**BEFORE THE BOARD OF PATENT APPEALS
AND INTERFERENCES**

Application Number: 10/674,852
Filing Date: September 29, 2003
Appellant(s): ASHFIELD, LEA ANTONY

EXAMINER'S ANSWER

Diagram 1. Labeled elements of the present limitations.

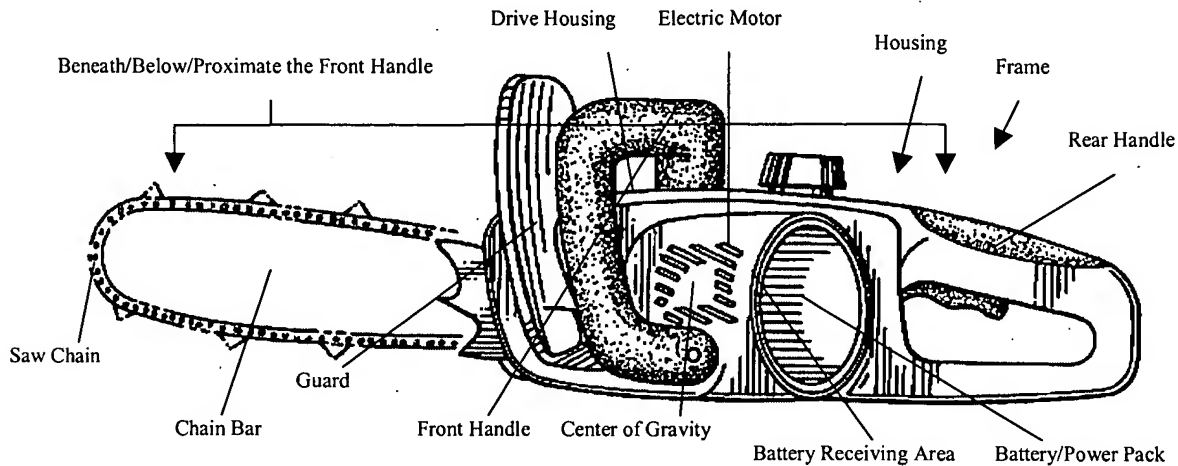
Claims 1, 4-6, 10, 14-16 and 20 are rejected under 35 U.S.C. 102(b) as being anticipated by Juratovac et al (D408,246), hereafter Juratovac. Juratovac discloses a battery operated chain saw with all of the elements described in the claim limitations. The figures clearly show a removable battery coupled to the motor in the figures. The battery and power pack is the oval shaped member shown in the figures. The electric motor lies within the vented motor housing shown in the figures adjacent to the oval-shaped battery. The center of gravity of Juratovac is located at least partially beneath the front handle as shown in the figures. The battery receiving area is on the back of the motor housing juxtaposed the oval-shaped battery and the motor housing as shown in the figures. The front-to-rear centerline is collinear with the rear handle and the battery is entirely spaced from the front-to-rear centerline as shown in figure 3. Juratovac inherently has an electrical coupling on the battery/power pack because every battery/power pack needs an electrical coupling in order to supply its power to a motor. Note the elements of the present limitations labeled below in Diagram 1.

Appellant asserts that the member indicated as “electric motor” in Diagram 1 above is not an electric motor because Juratovac is a design patent and does not have an enabling disclosure for an electric motor. However, one of ordinary skill in the art recognizes that motors must be kept in vented housings in order to exhaust heated air created by the heat in the motor. As shown in figures 1 and 4 of Juratovac, there is only one element that has venting, therefore, the vented housing contains the electric motor.

Appellant asserts that the oval shaped member indicated as “Battery/Power Pack” in Diagram 1 above is not a battery/power pack because Juratovac is a design patent and does not have an enabling disclosure for a Battery/Power Pack. However, the title of the Juratovac reference is “Housing for a *Battery* Operated Chainsaw,” which is a disclosure that Juratovac has a battery. One of ordinary skill in the art would have interpreted the oval-shaped member shown in the figures, and labeled in Diagram 1 above, as a Battery/Power Pack because the size of the oval-shaped member is proportional to the size of the battery needed to operate other battery-powered tools, such as the battery/power pack 30 in the Anthony, III reference.

One of ordinary skill in the art would have known that the center-of-gravity lies in a plane that is below the front handle because as shown in Diagram 1 above, the front handle is the highest (vertically) element of the Juratovac chain saw save for a small portion of the guard. If the center-of-gravity were not located at least partially beneath the front handle, then the front handle would have to significantly outweigh the motor, the battery, the housing, the chain bar and the saw chain, which is impossible.
